SERIES: CROSSROADS  
FLOOR PLAN: CR2306  
2306 SQUARE FEET

SHEET NO.	MODEL # CR2306	COLONNADE	PYATT BUILDERS CARMEL, INDIANA 46032 PYATTBUILDERS.COM
DATE: 5/24/23			
DRAWN BY: AJP	BUYER: SPEC	LOT# :000	COPYRIGHT 2023

SERIES: EXCLUSIVES  
FLOOR PLAN: E2655  
2655 SQUARE FEET

### REAR ELEVATION

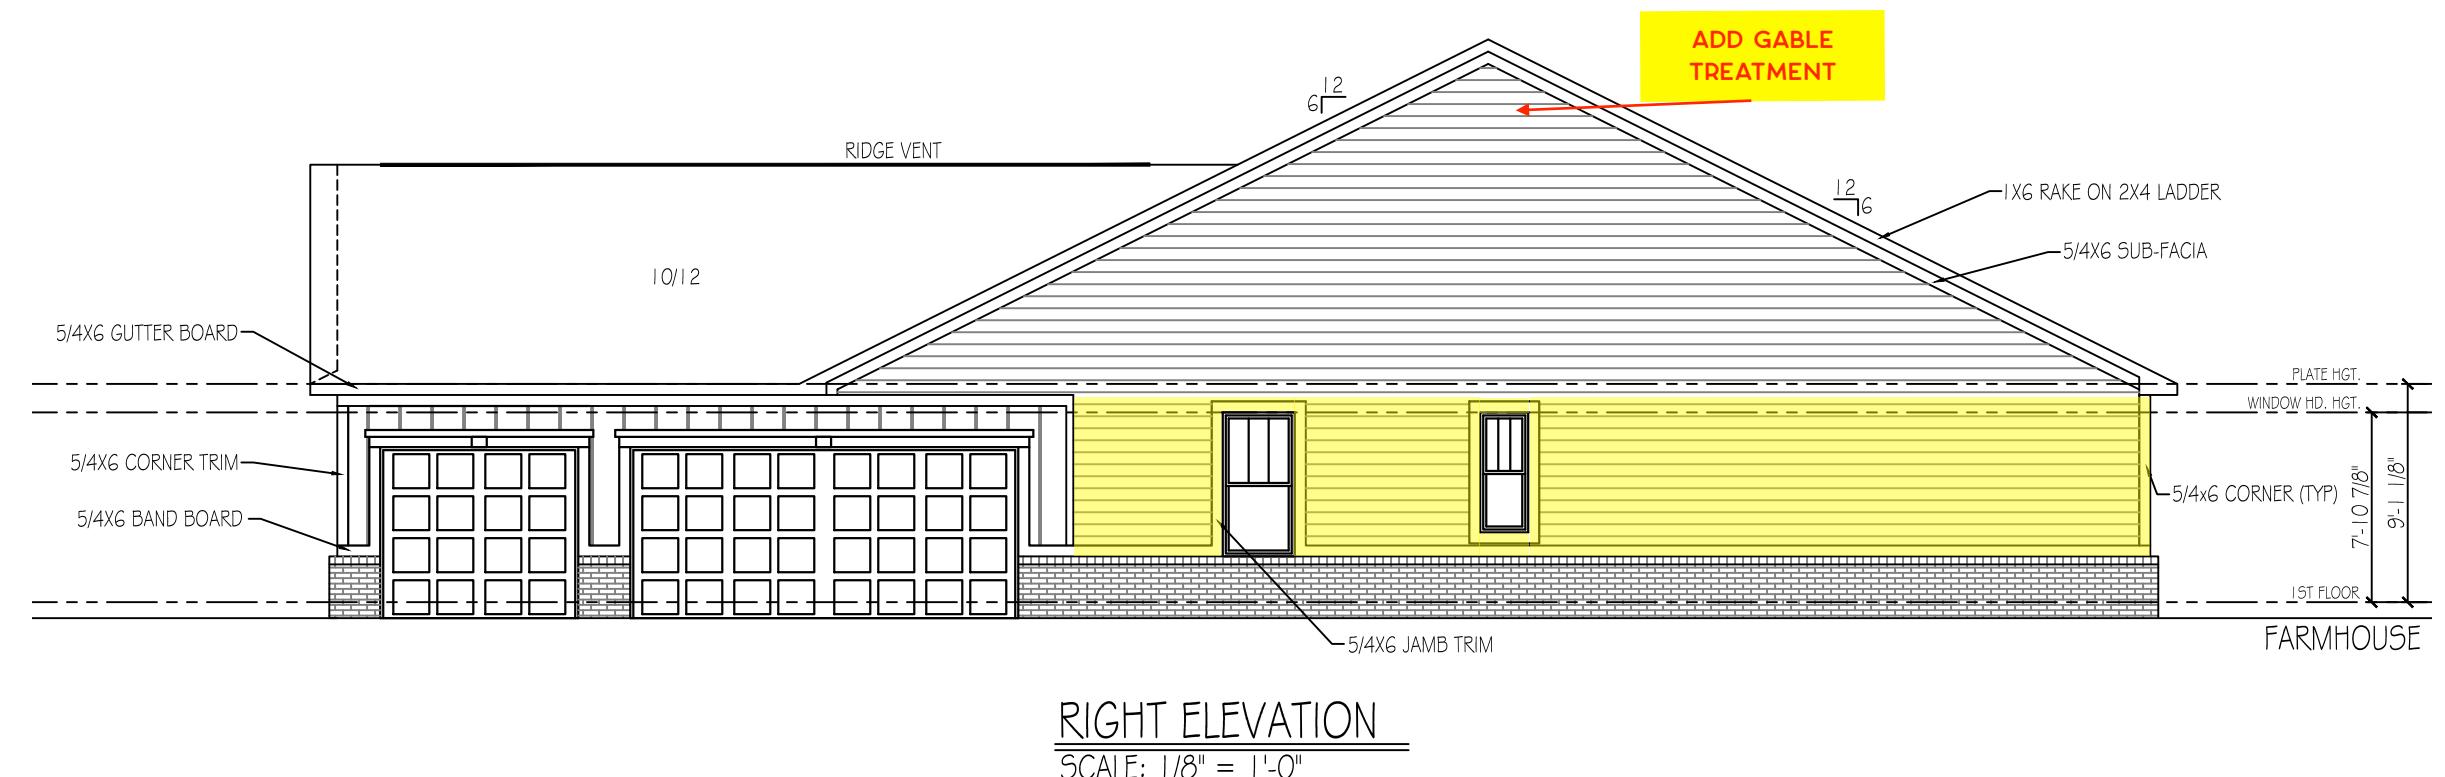
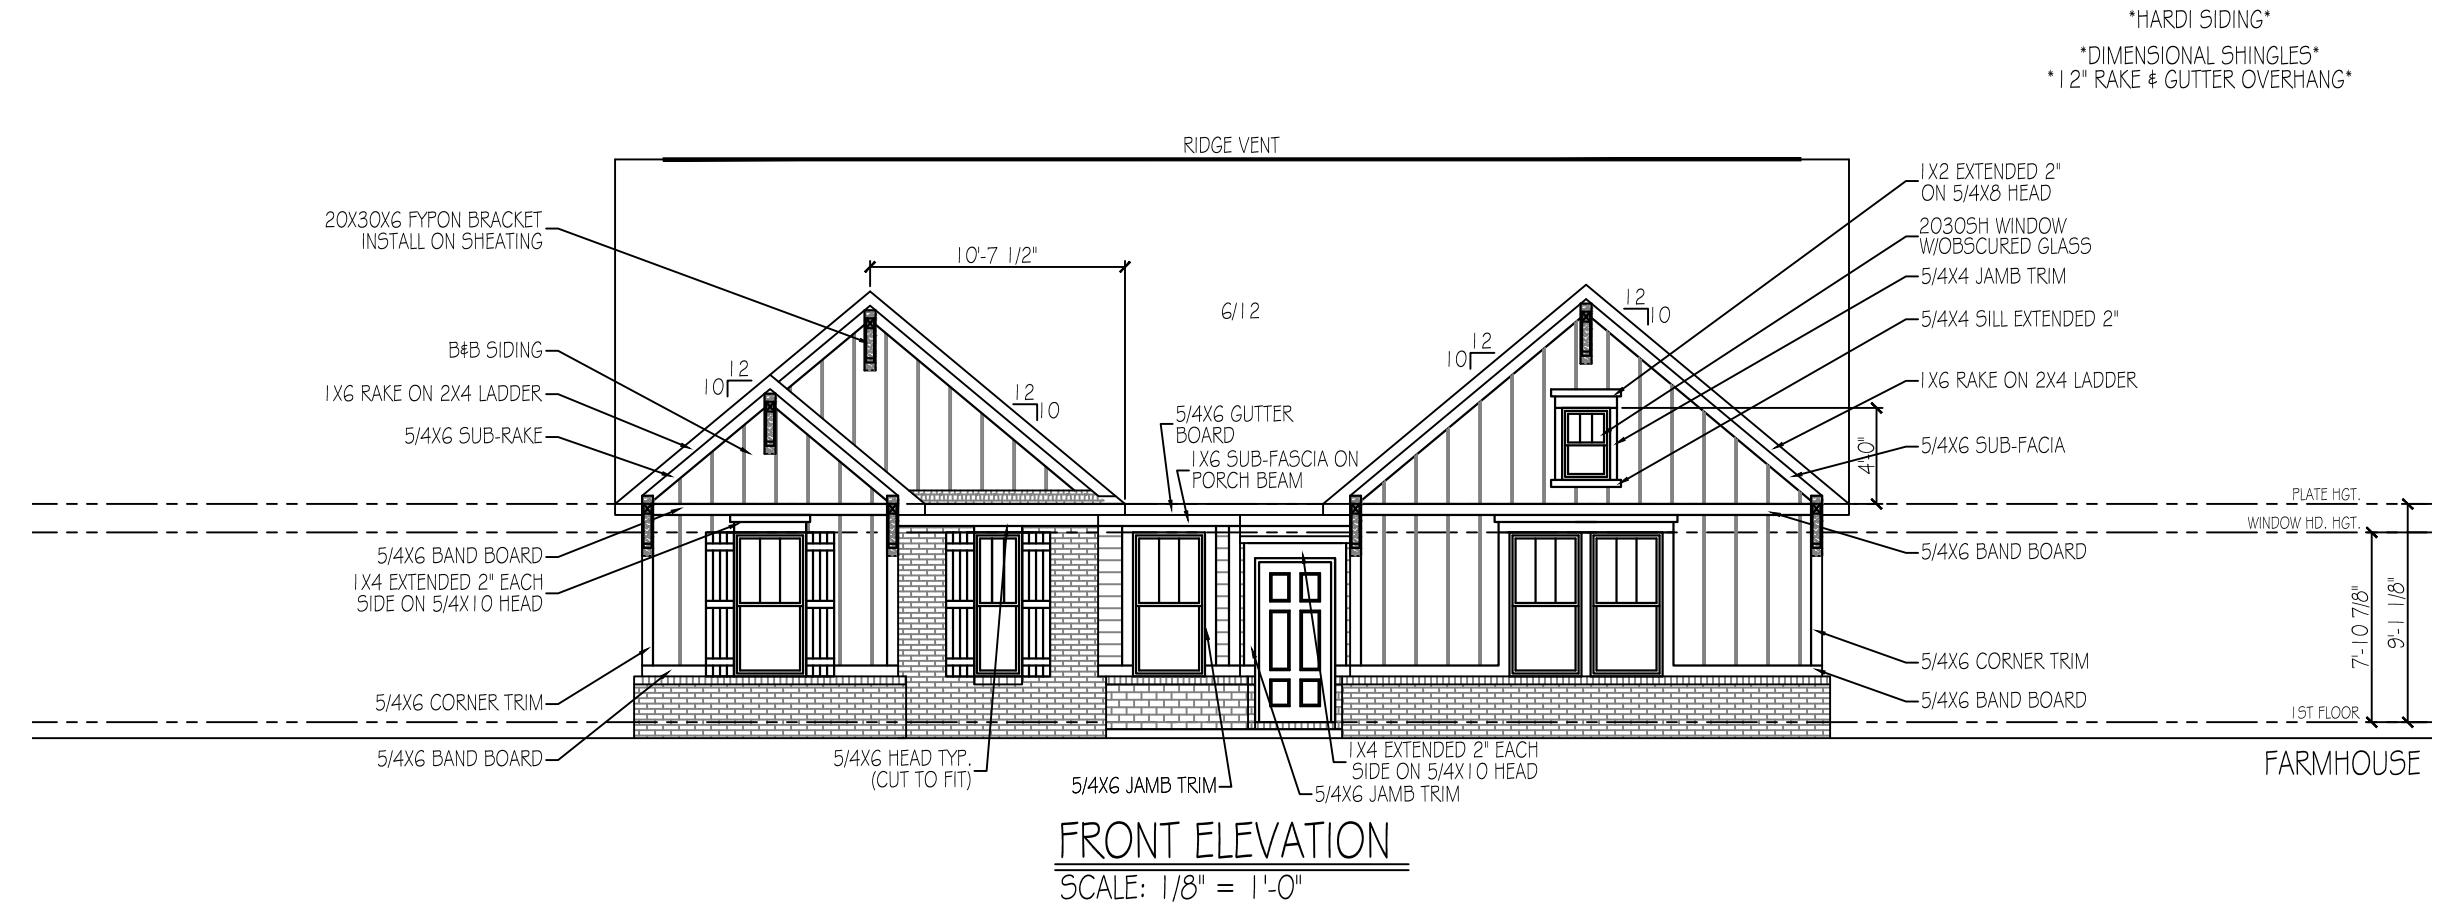
APPROVED ELEVATION WITH BRICK WRAP CHANGES REQUESTED

LEFT SIDE ELEVATION

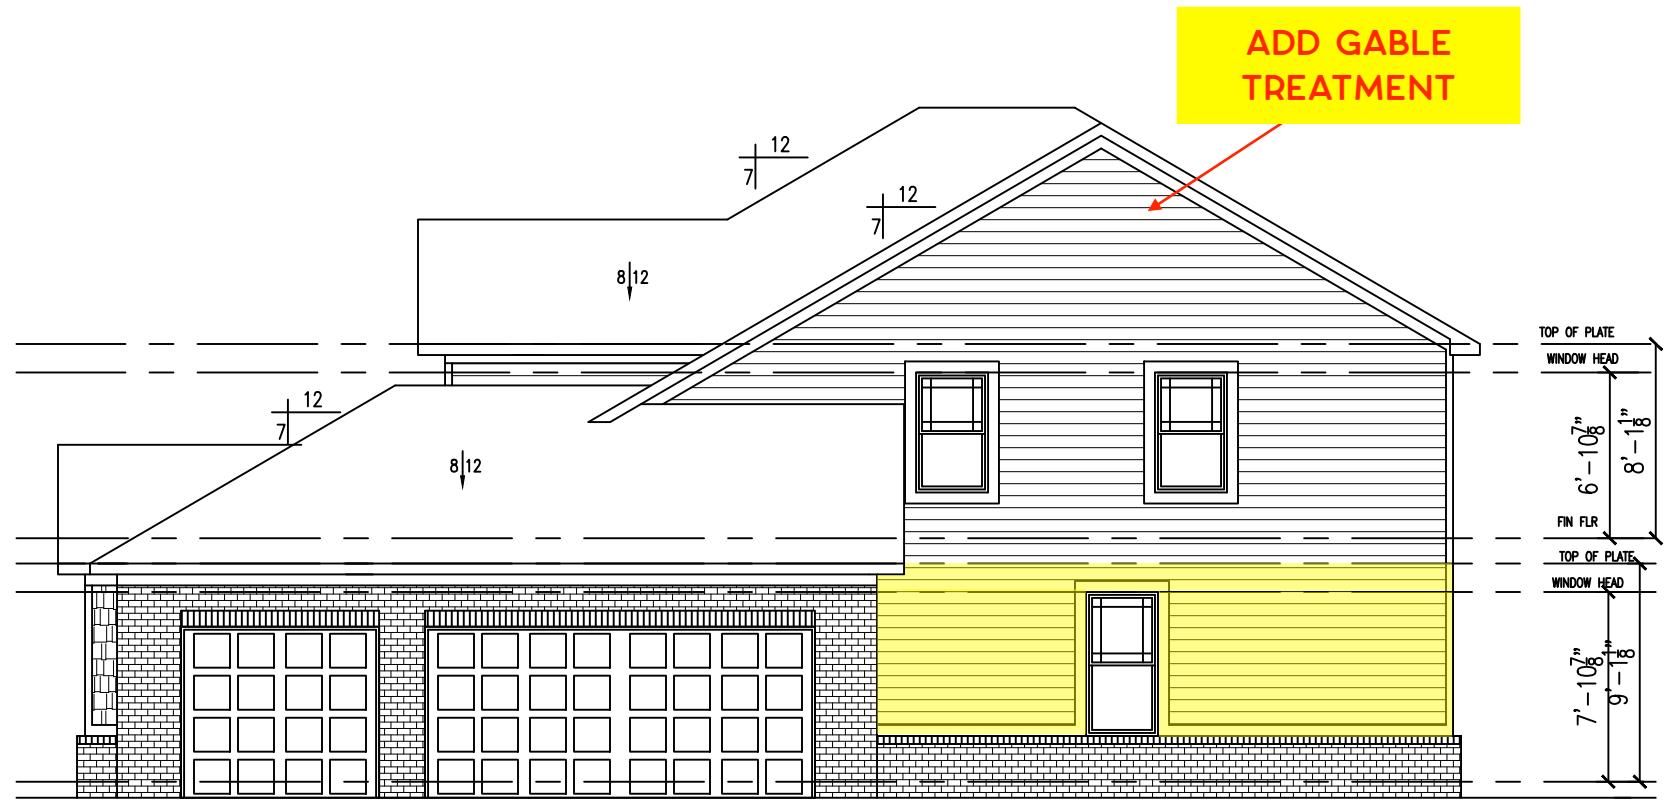
APPROVED ELEVATION WITH BRICK WRAP CHANGES REQUESTED

LEFT SIDE ELEVATION

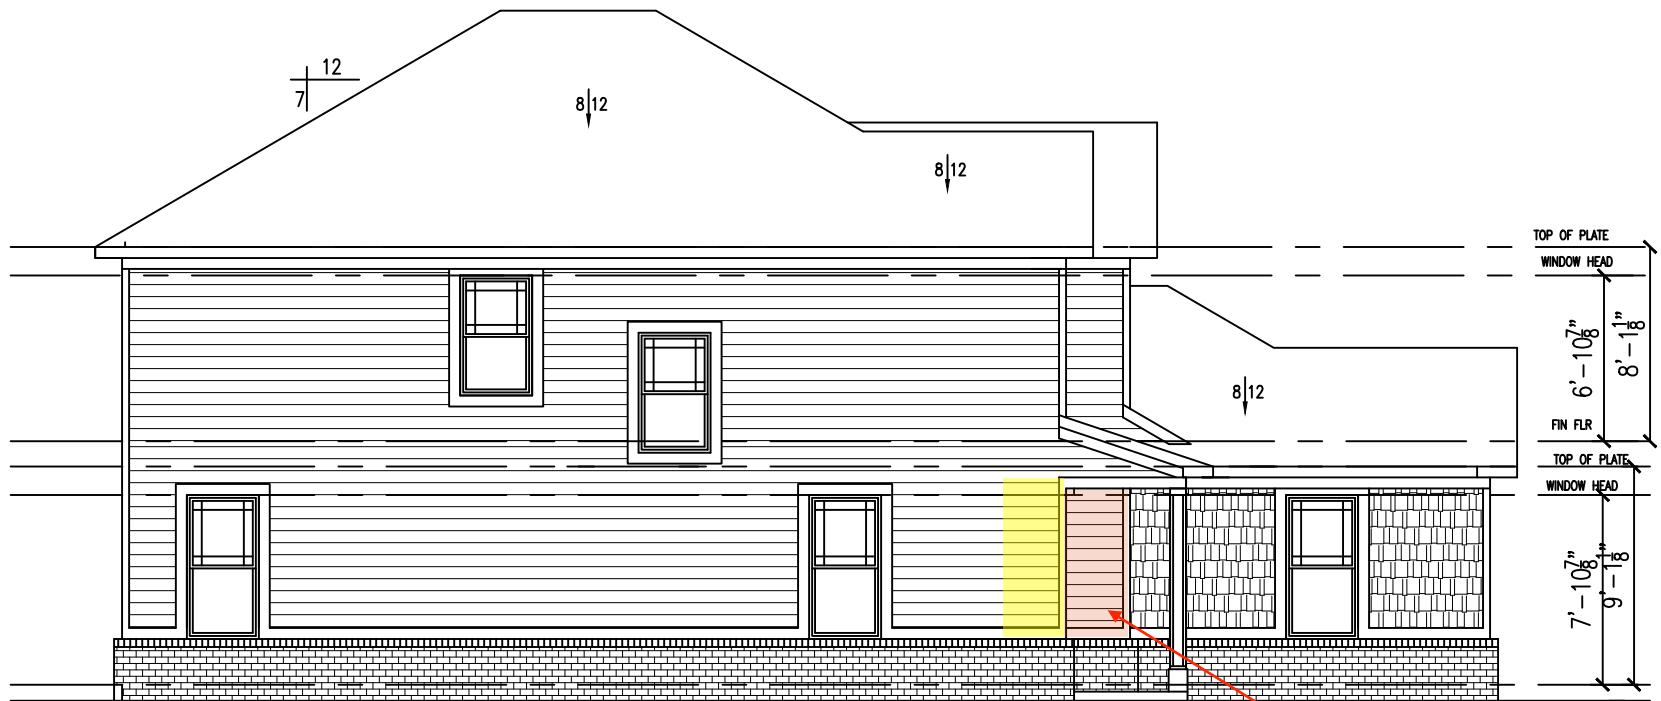
CHANGE TO  
SHAKE

EXCLUSIVES 2867 MODERN PRAIRIE

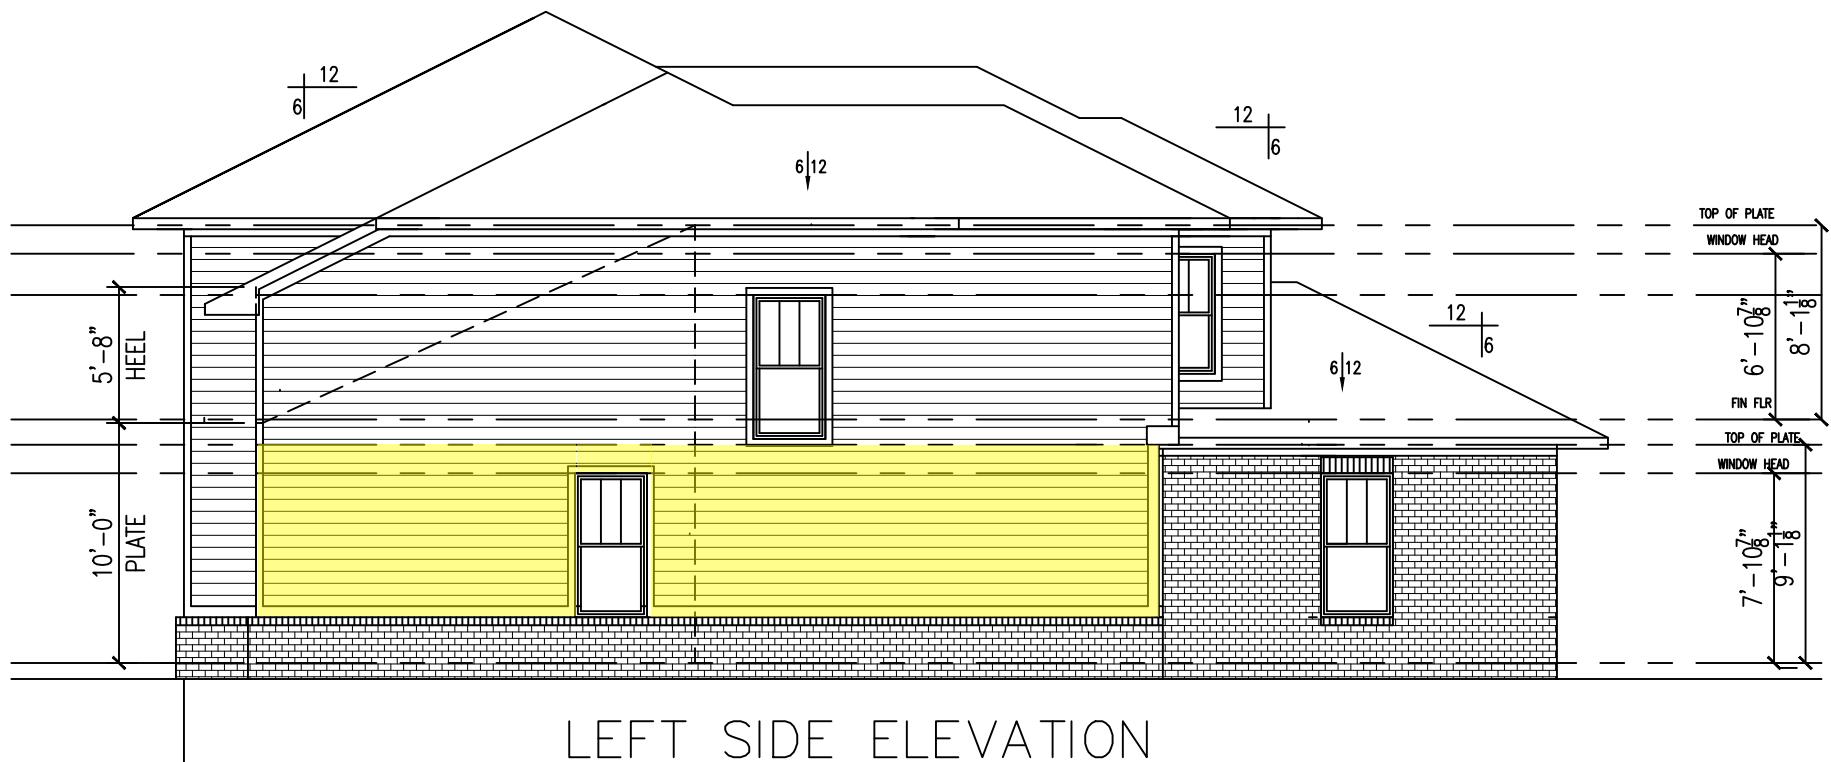
CHANGE TO 5/12  
ROOF PITCH ON  
MAIN BODY AND  
GABLES

RIGHT SIDE ELEVATION

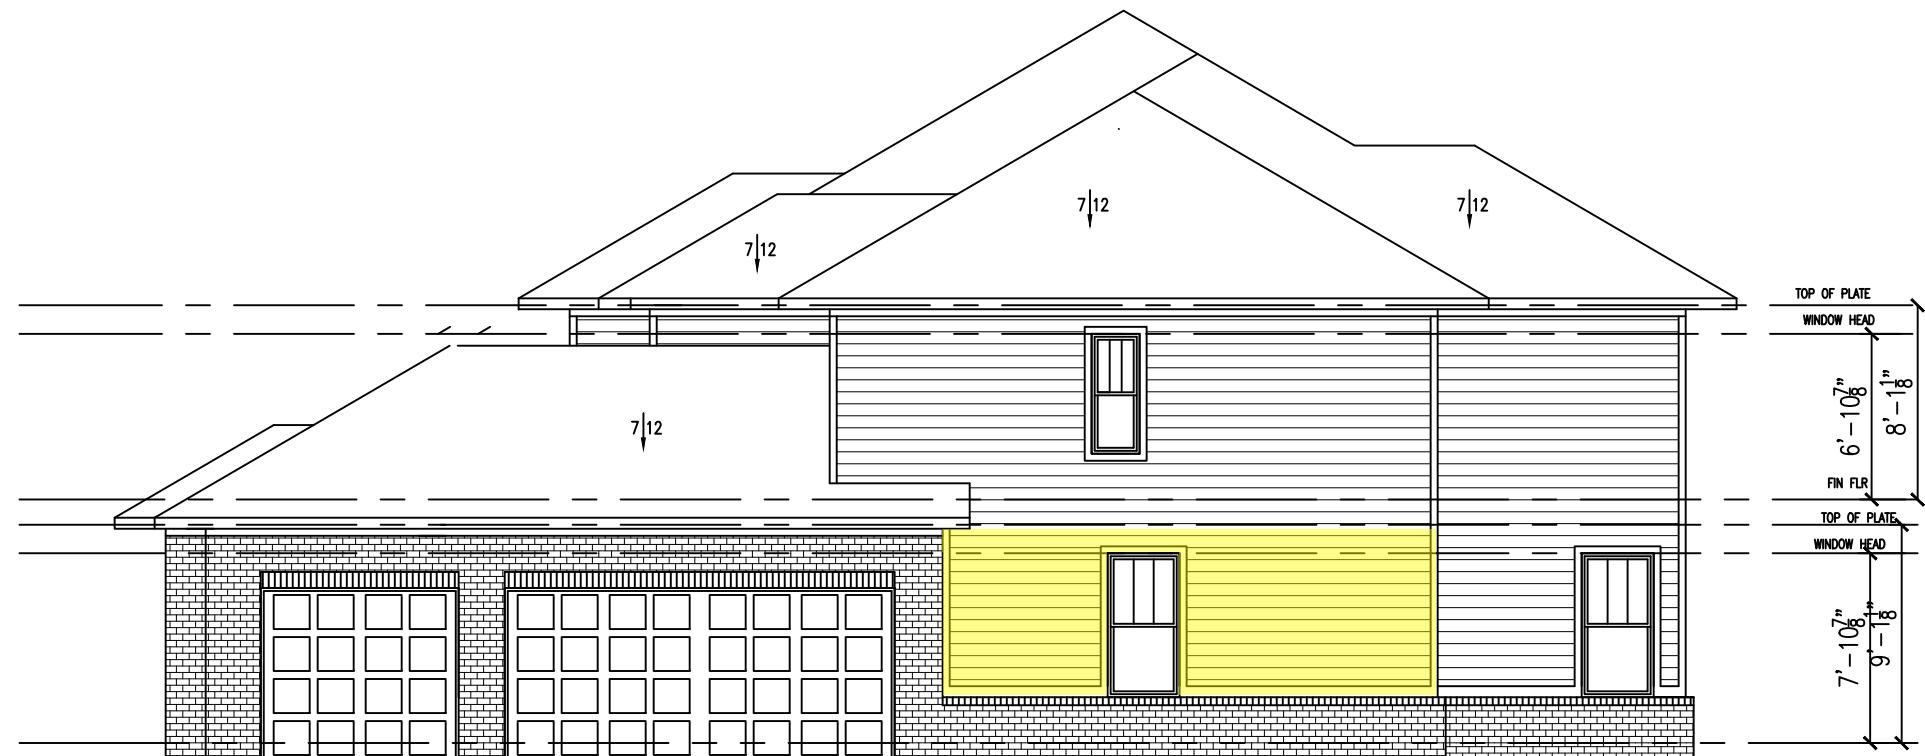
CHANGE TO 5/12  
ROOF PITCH ON  
MAIN BODY AND  
GABLES

CHANGE TO 5/12  
ROOF PITCH ON  
MAIN BODY AND  
GABLES
